## MTDAWWG SMALL CONTRACTOR'S YARD TABLE OF CONTENTS

#### MTDAWWG SMALL CONTRACTOR'S YARD

#### **STAFF REPORT**

**File No.** GAPA 10-24-9041

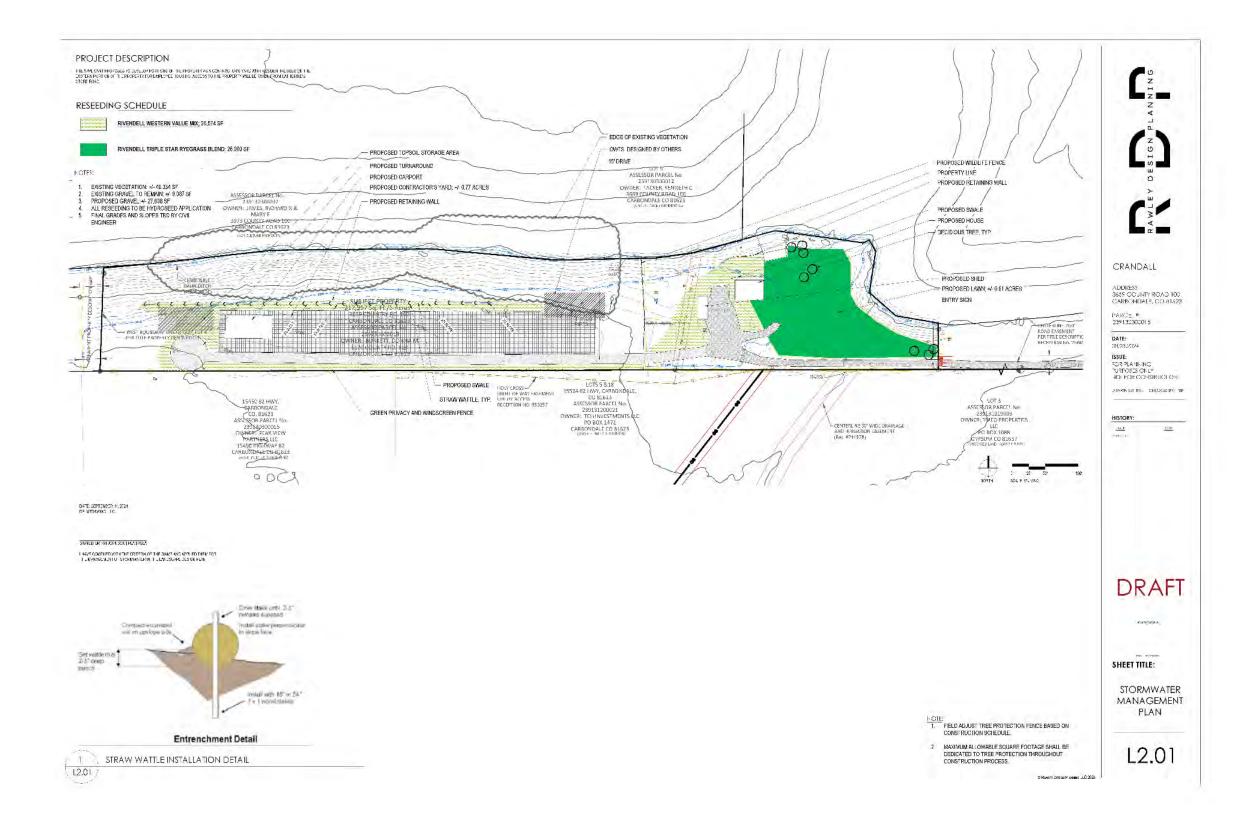
The application does not specify what surface will be used for the yard itself, though the applications response to Article 7 Standards indicate that gravel is proposed for at least the driveway and turnaround. A green privacy fence and wind screen is proposed along the southern boundary. A copy of the site plan is provided on the following page. The yard will also have a "carport" that will be used for non-vegetative material storage and maintenance uses.

A future retaining well is shown on the proposed site plan running roughly along the tree line and what appears to be a small ditch lateral.

**Section 4-203.E Grading and Drainage Plan** – The consulting engineer noted that the total disturbance on the property might exceed the 1-acre threshold to require a CDPHE Stormwater Discharge Permit. The site plan also had a proposed retaining wall that appears to intersect a

ditch. The application states that the retaining wall is proposed later., but staff recommends additional information be provided on this ditch and the proposed retaining wall. The consulting engineer also noted that the proposed improvements will probably generate stormwater runoff, and full grading and drainage plan that meets the LUDC's requirements should be provided.

- 3. Prior to issuance of the Land Use Change Permit, a full grading and drainage plan that meets the requirements of Section 4-203 shall be provided for review. A more detailed waiver of submittal requirements that satisfies the requirements of 4-201 may be accepted, subject to staff review. This plan should address all proposed surfacing for the Yard and driveway, and it needs provide calculations related to total area of disturbance. This should also address whether a CDPHE Stormwater Discharge Permit is required and, if so, provide a copy. This permit will also function as a Grading Permit.
